Addendum Review of Environmental Factors

Re-development of the Blayney Multipurpose Service Facility –
Addendum 1

20/12/2024

Figure 20: Extracts of Approved Stage 2 General Arrangements Landscaping Plan (left image) and Proposed Amended Stage 2 General Arrangements Landscaping Plan (right image)

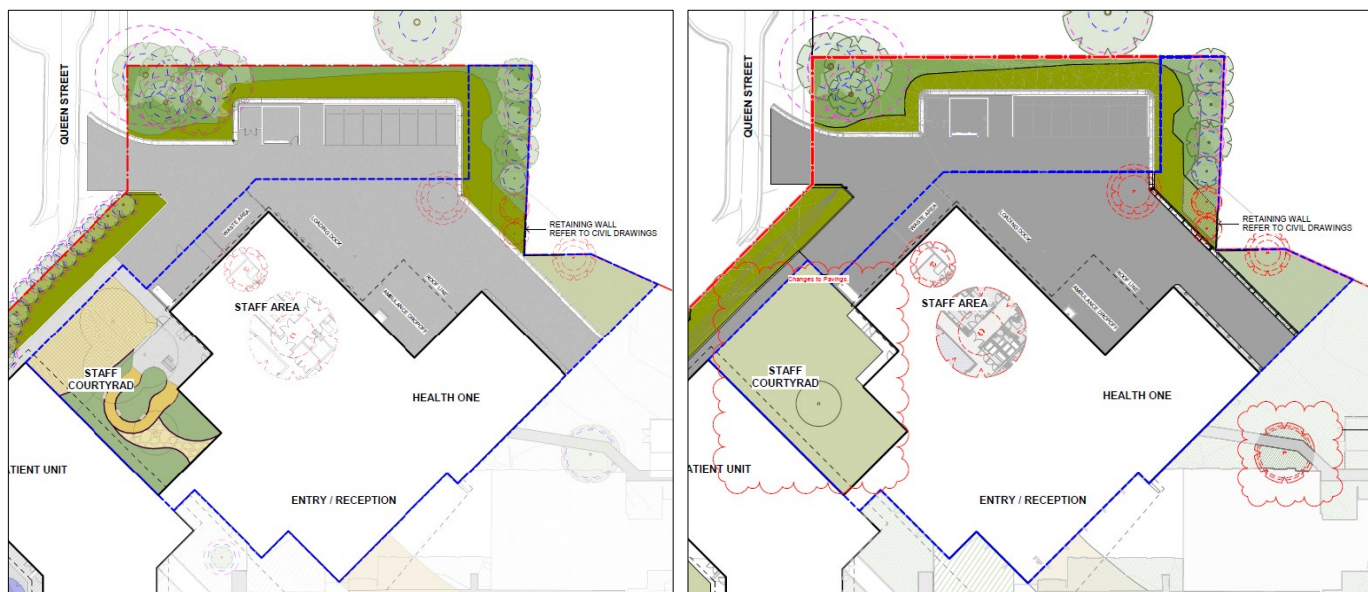
This Addendum REF is accompanied by an *Amended Landscape Package* – refer to **Appendix E**. The proposed landscaping changes are a result of proposed flood mitigation works, civil design changes and value engineering requirements. The proposed amended landscaping regime is compared to the approved landscaping regime within **Figure 18, Figure 19, Figure 20 and Figure 21** below.

- replacement of selected areas of soft-fall and hardscape / paving with turf;
- change in selected hardscape materials (e.g. replacement of abrasive concrete finish and pavers with coloured concrete);
- removal of selected landscape features (e.g. feature boulders, sandstone blocks);
- removal of selected outdoor furniture (e.g. seating);
- changes to landscaping design in response to amended carpark locations, as described above (e.g. replacement of previously approved new carparking area with turf and trees); and
- changes to selected plant selection details (e.g. pot sizes, plant spacing).

Figure 23: Extract of plan showing Proposed Amended pedestrian access network between Osman Street and the MPS main entry

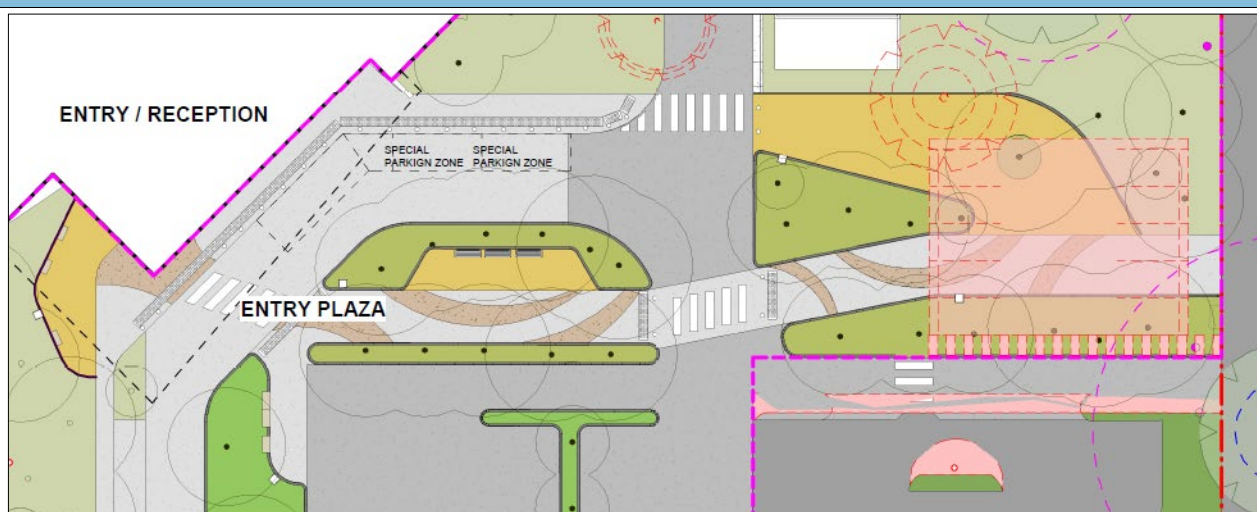
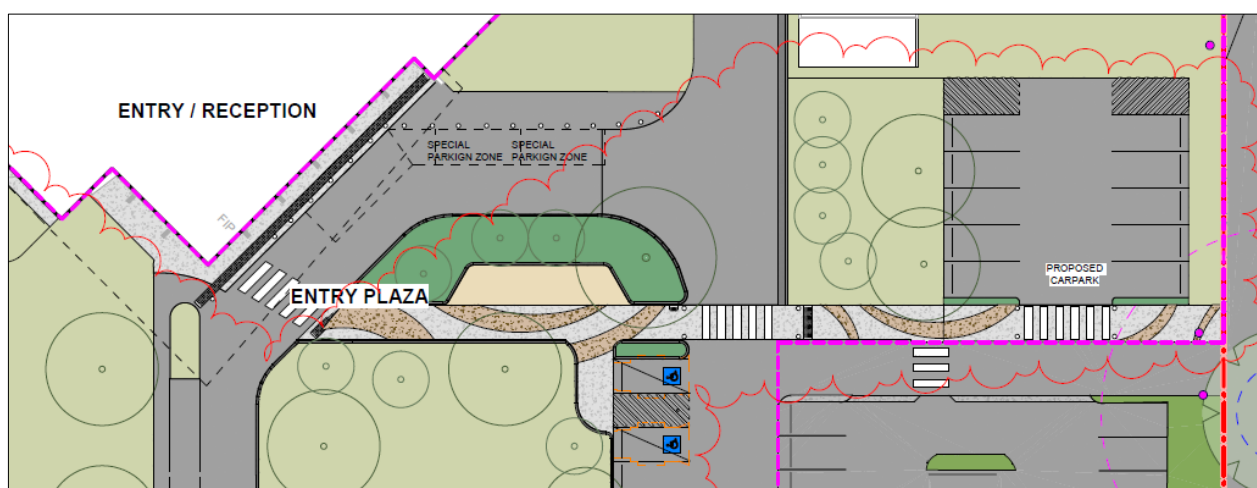
With regard to the pedestrian network, the proposed civil design changes include an amended footpath layout, as indicated in **Figure 22** and **Figure 23** below. The changes include the removal of a pedestrian path and crossing from directly adjacent to the 'special parking zones' at the MPS entry leading to Osman Street. It also includes the straightening of the remaining path trajectory to Osman Street, and a minor narrowing of its width.

The proposed removal of the northern path, as described above, is considered to result in negligible negative impacts. Although the previously-approved northern path provided an additional option for pedestrians, it did not provide any unique or more-convenient travel path. In practice, the remaining footpath was most likely to be the most frequently utilised due to its direct connections between the street, the carparking areas and the main entry. Further, while narrowed, the amended path width appears adequate to cater for wheelchairs and other uses, and will comply with the relevant Australian Standards in this regard. Accordingly, the pedestrian access network within the site remains acceptable.

Figure 25: Design conditions 1% AEP flood event depth - as Amended, including proposed flood mitigation works

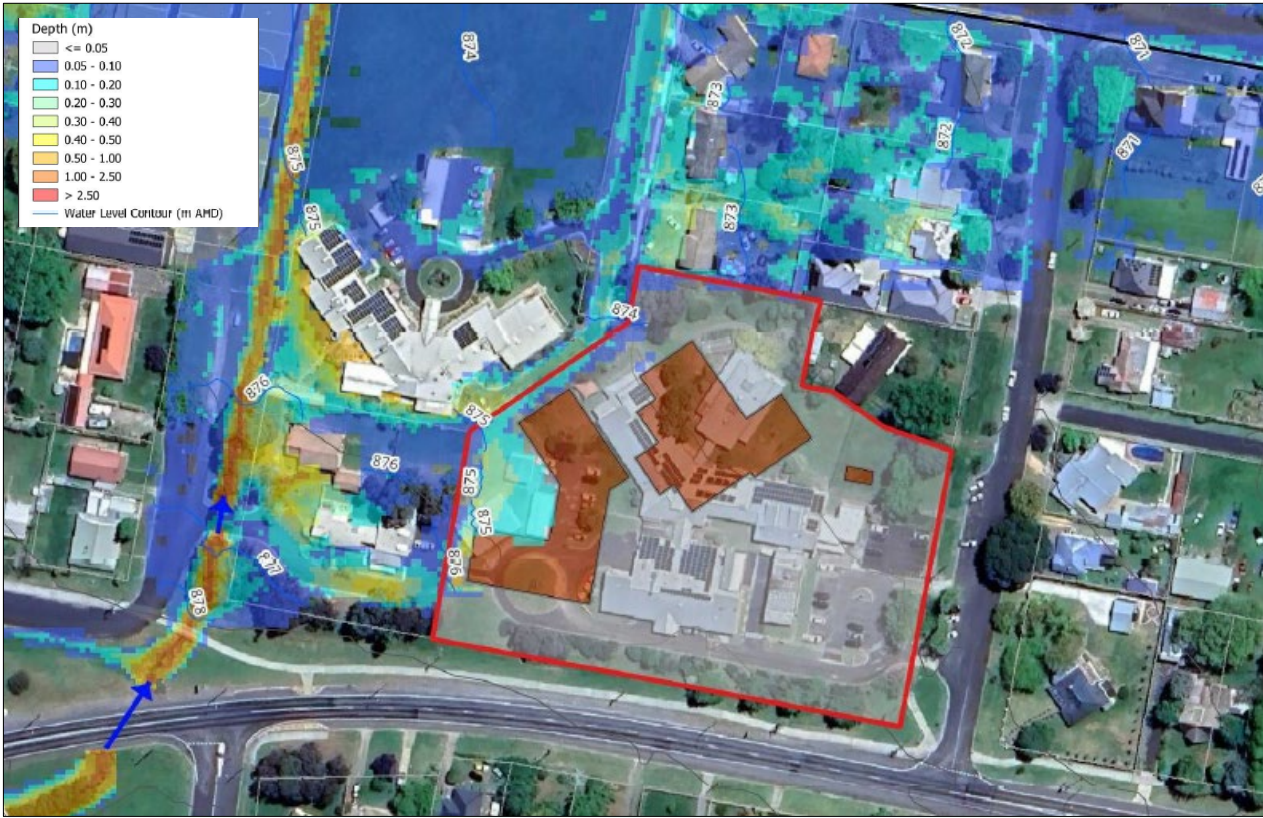
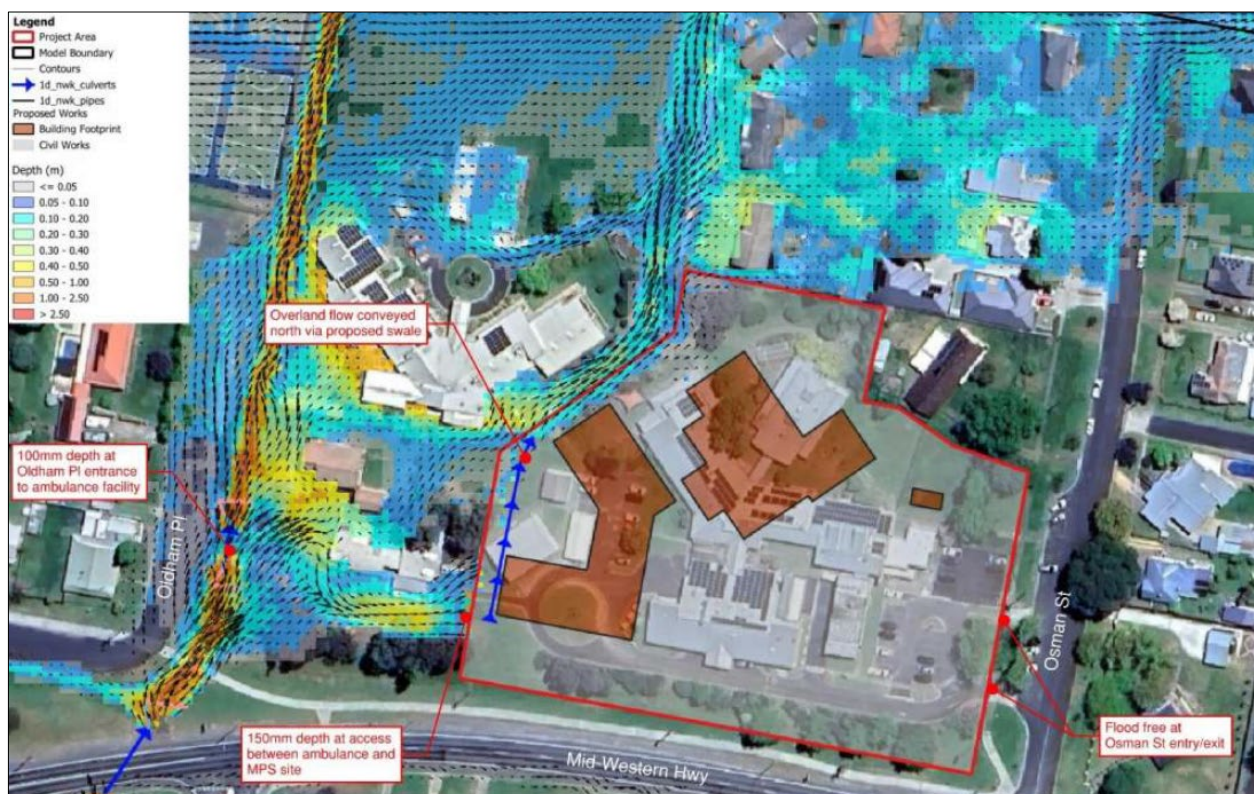
Issue	Discussion
Hydrology, Flooding and Water Quality	<p>As outlined in Section 3.1, the Amended Proposal involves changes to the grading of the site, as well as to the stormwater drainage system, most notably via the addition of a new turf-lined swale along the site's western boundary.</p> <p>With regard to flooding impacts, the <i>Flood Risk Assessment (FRA)</i> at Appendix C modelled the post-development conditions of the Approved development (i.e. with no flood mitigation works) compared to the proposed Amended design (including proposed flood mitigation works). The key differences between the Approved and Amended modelled post-development conditions are outlined below:</p> <ul style="list-style-type: none">In the Approved scenario, the overland flows travelling from the Ambulance Station and along the western boundary of the site potentially result in flooding over floor of the Residential Aged Care wing of approximately 300 mm (1% AEP flood level of 875.15 m, AHD) – see Figure 24 below. In the Amended scenario, overland flow originating from the Oldham Place swale to the west of the site and transversing through the Ambulance site is effectively captured by the proposed swale and directed north (as shown in Figure 25). The swale results in the proposed MPS buildings achieving flood immunity to the 1% AEP flood event. The existing flowpath passing along the Mid-Western highway at the southern boundary of the site is cut off by the proposed works, resulting in a reduction in surface water flooding within properties immediately to the north-east of the site as demonstrated in Figure 5-12 of Appendix C.Flood hazard is shown to largely remain as H1 (generally safe for vehicles, people and buildings) in the 1% AEP event with a small patch of hazard category H3 (unsafe for vehicles, children and the elderly) observed where flows enter the proposed swale.

As outlined above, the Amended design results in a net positive benefit for the site as it results in flood immunity for all MPS buildings up the 1% AEP flood event. Further, based on the modelling results, the FRA concluded that *there is no material change between the approved design and the mitigation measures proposed with respect to flood depth, level or hydraulic hazard. As such, the implementation of the diversion swale does not increase the impacts to the community or the Lee Roshana Aged Care Facility* (p25).

Figure 26: Sub-catchments in the Approved design (left image) compared to sub-catchments in the proposed Amended design (right image)

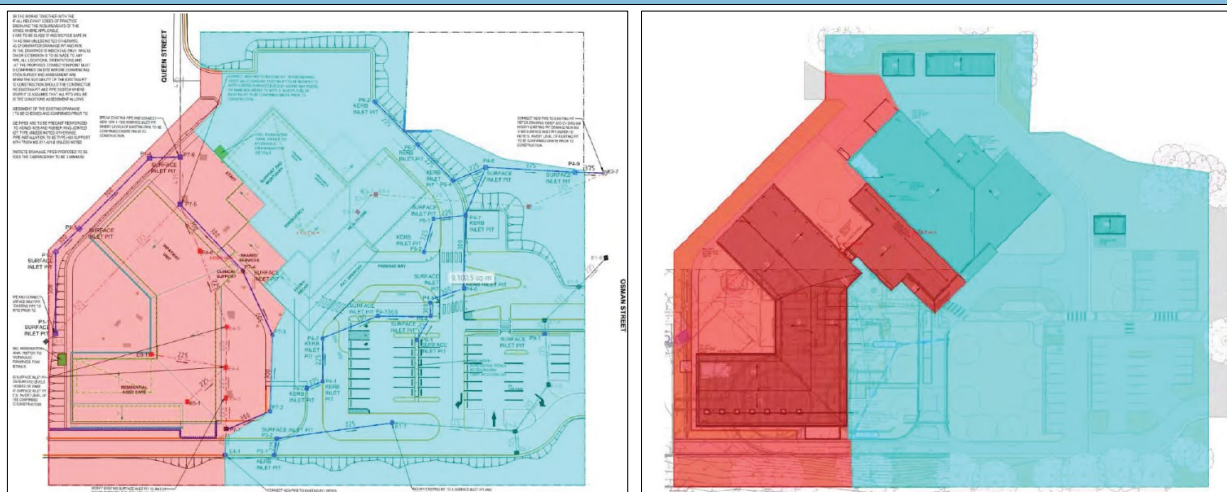
Refer to **Figure 26** below. As demonstrated above, despite the proposed changes to the stormwater network, the resulting catchment areas for each LPD remain generally similar.
